# UNITED STATES PATENT AND TRADEMARK OFFICE

APPLICATION NO.	FILING DATE	FIRST NAMED INVENTOR	ATTORNEY DOCKET NO.	CONFIRMATION NO.
10/529,002	12/15/2005	Joachim Haedicke	2002P00990WOUS	8810
46726 7590 01/18/2008 BSH HOME APPLIANCES CORPORATION INTELLECTUAL PROPERTY DEPARTMENT 100 BOSCH BOULEVARD NEW BERN, NC 28562				
EXAMINER				
WONG, KWOK CHEUNG				
ART UNIT		PAPER NUMBER		
4156				
MAIL DATE		DELIVERY MODE		
01/18/2008		PAPER

### Office Action Summary

3. Figures 4 & 6 (below) from Kolze et al. discloses the elements of Claim 14 as follows:

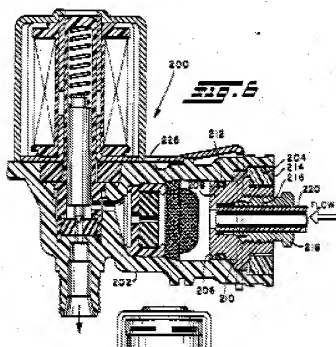
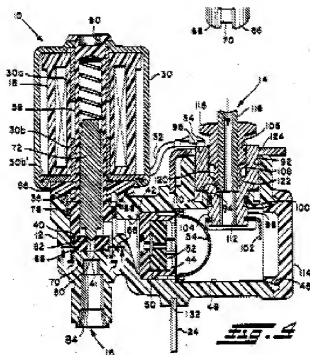
A gas tap (as seen in Figs 4 & 6) including a gas path (as seen in Figs 4 & 6), comprising:

an electromagnetic safety valve for closing the gas path [Abstract, Lines 1-6];

said safety valve including an armature housing (as seen in Figs 4 & 6) and having

a mobile magnetic anchor in said housing [Column 5, Line 30; as seen in Figs 4 & 6];

a valve seat [Column 5, Lines 4-8];

said mobile magnetic anchor including a valve closing element which presses on said valve seat to close said gas path [Column 5, Lines 30-39];

an electromagnetic coil for activating said mobile magnetic anchor and valve closing element to close said gas path when voltage is applied to said electromagnetic coil [Column 2,

said electromagnetic coil arranged as a separate component

outside of said armature housing on a magnetic insert

4. In Claim 15, Figures 4 & 6 of Kolze et al. show the electromagnetic coil arranged separate from the gas path.
5. In Claim 16, Figures 4 & 6 of Kolze et al. show the electromagnetic coil outside of the armature housing and is able to be detached.

6. In Claim 17, Figures 4 & 6 of Kolze et al. show the electromagnetic coil outside of the gas tap.
7. In Claim 18, Figures 4 & 6 of Kolze et al. show the electromagnetic coil partially protruding outside of the gas tap.

8. In Claim 23, it can be seen from Figures 4 & 6 of Kolze et al. that the armature housing has one section set inside the gas tap and another section projecting from the gas tap.

9. In Claim 24, Figures 4 & 6 of Kolze et al. show a portion of the armature section set inside of the gas tap similar in structure to that of housing sections of a magnetic insert.

10. Figures 4 & 6 (above) from Kolze et al. discloses the elements of Claim 26 as follows:

**Fig. 4**

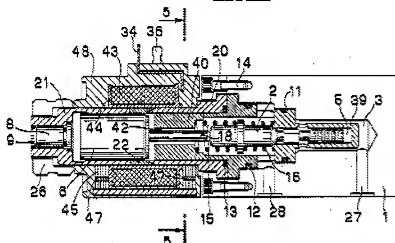
In Claim 20, Tirelli '399 [Column 6, Lines 18-31] teaches the use of an anchor guide section positioned inside of a gas tap for sealing engagement and an anchor guide section positioned outside of the gas tap as shown in Figure 4 of Tirelli '399 below.

In Claim 25, Tirelli '399 [Column 5, Lines 9-13; Column 6, Lines 32-43] teaches the use of counter-anchor as a device to attract (or repel) the magnetic anchor (armature) via a magnetic field as a result of an electric current applied to the electromagnetic coils. It is clear from Figure 4 above that at least one of electromagnetic coil, armature housing sections, counter-anchor are provided on a second armature housing section projecting from the gas tap.
